UNITED STATES
NUCLEAR REGULATORY COMMISSION
WASHINGTON, D. C. 20555

CALVERT CLIFFS NUCLEAR POWER PLANT UNIT NO. 1

AMENDMENT TO FACILITY OPERATING LICENSE

Amendment No. 49
License No. DPR-53

FIGURE 3.1.2.a-1 - STATIONS ON THE UPPER CHESAPEAKE BAY IN THE VICINITY OF CALVERT CLIFFS NUCLEAR POWER PLANT. STATION DESIGNATIONS ARE AS FOLLOWS:
 KB - KENWOOD BEACH; LB - LONG BEACH; PS - PLANT SITE;
 RP - ROCKY POINT; CP - COVE POINT

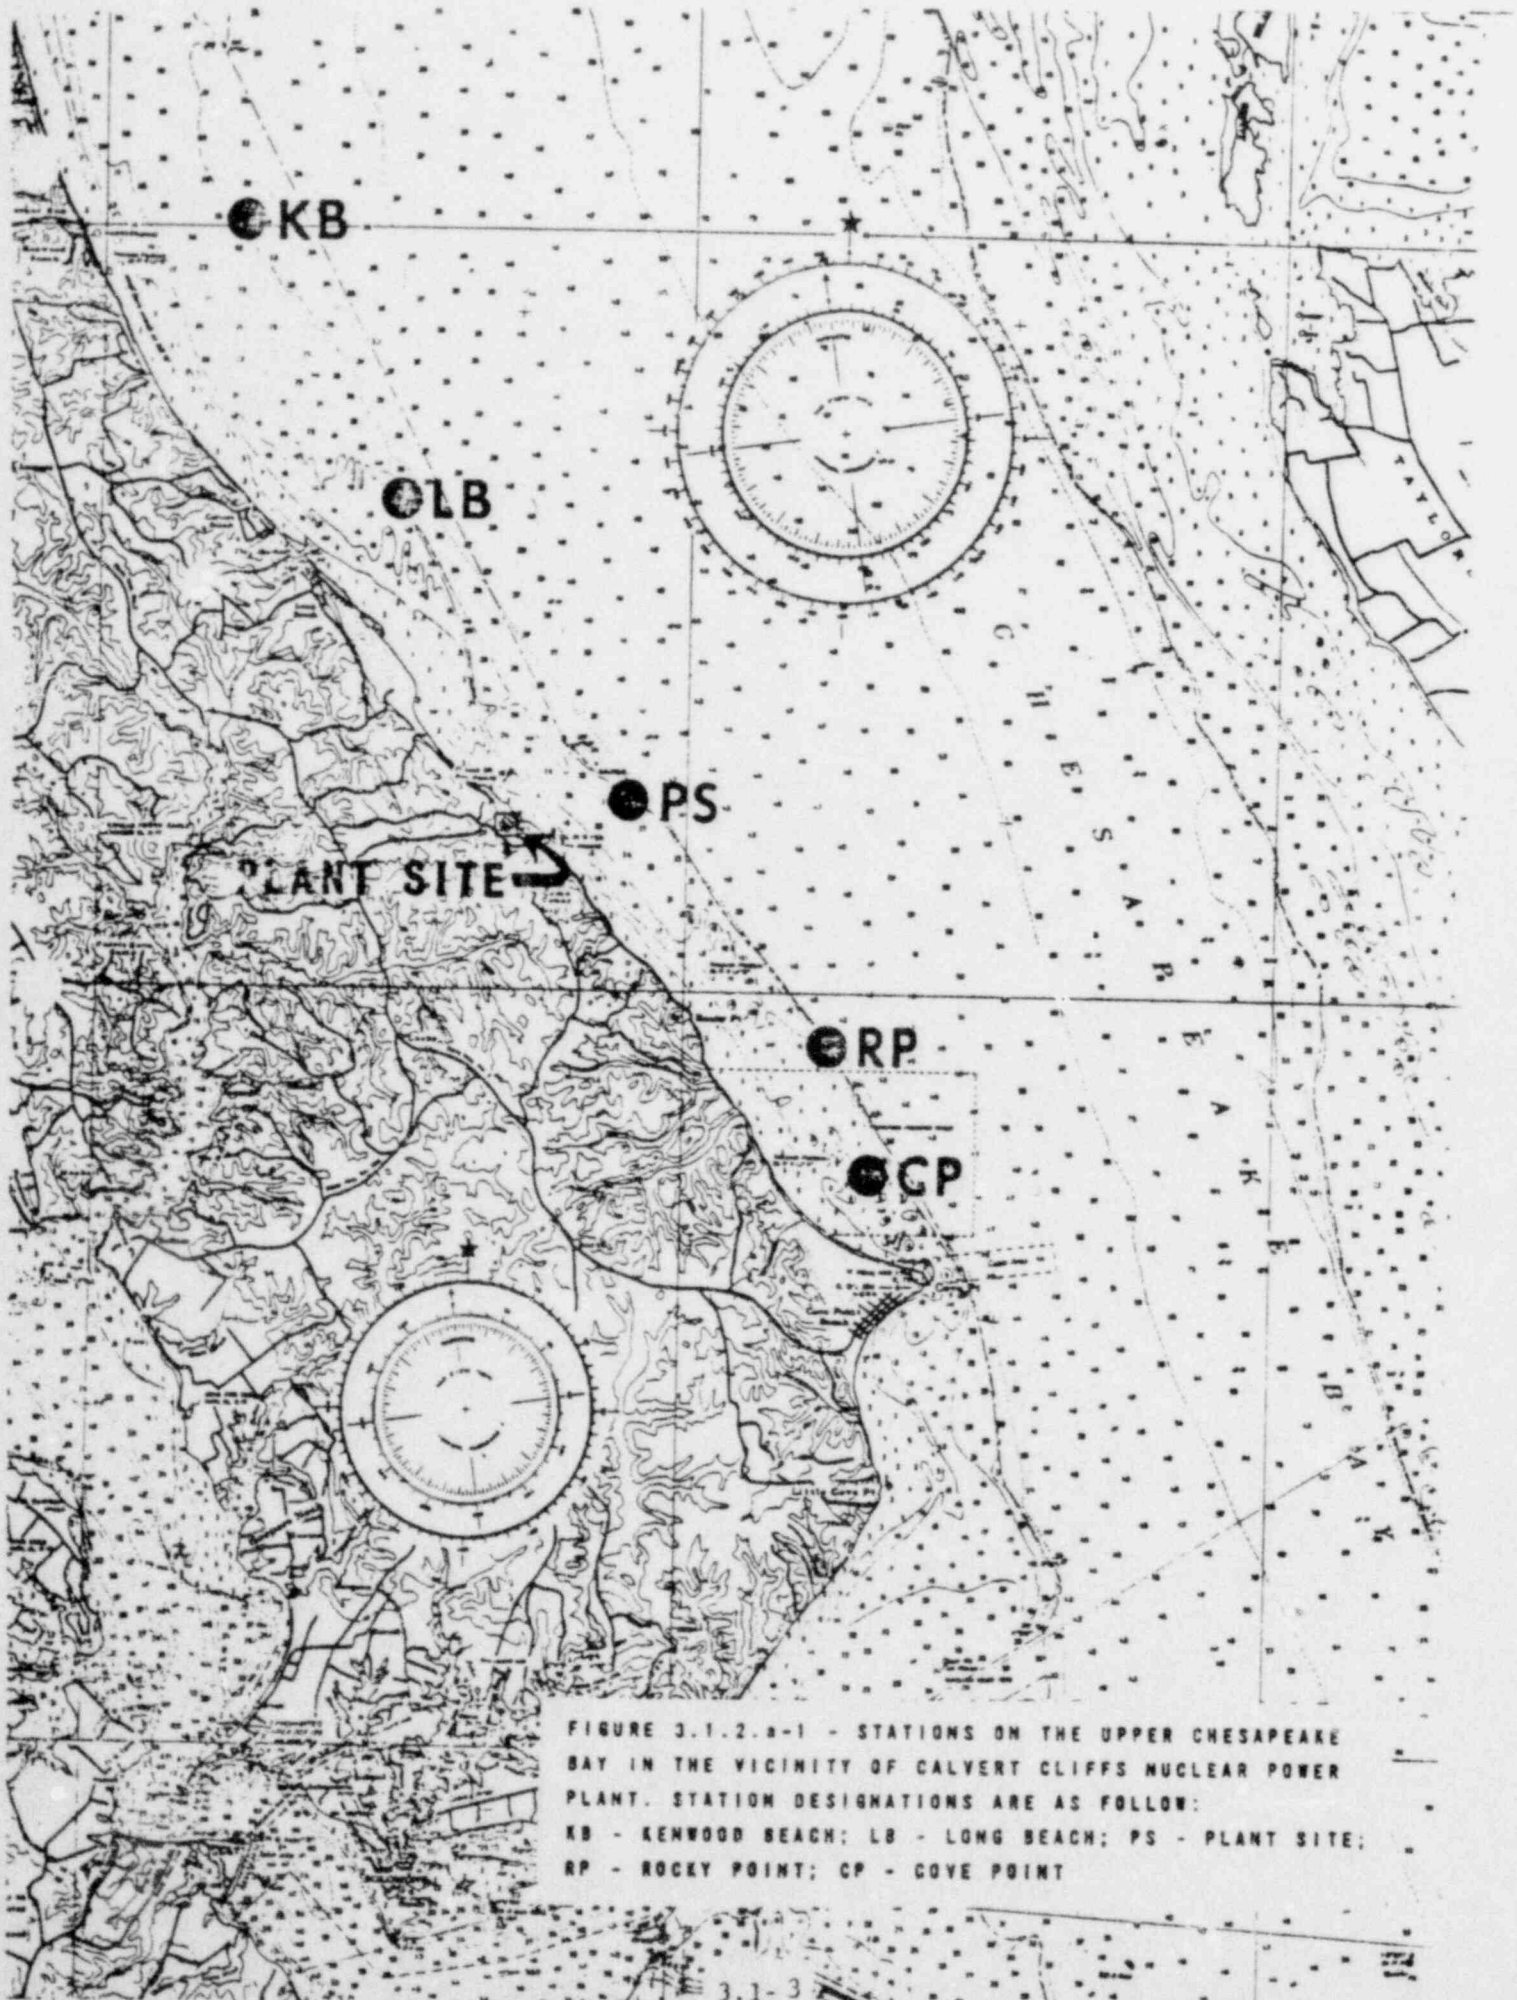
In 1968 a program of ecological surveys was begun to gather information regarding possible environmental effects of the Calvert Cliffs Nuclear Power Plant. In designing this program, sampling stations were selected so that areas influenced and areas not influenced by plant activities were represented. Over the years this program has been expanded and modified to reflect changing concerns and the experience gained in previous years. This program is still evolving in response to the above factors and to changing State and Federal regulatory requirements. The above specifications are considered to be the nucleus of these studies and are not expected to change. Data collected during these surveys shall be evaluated annually and recommendations made to modify or continue the program of studies. The approximate location of sampling stations is shown in Figure 3.1.2.a.-1.
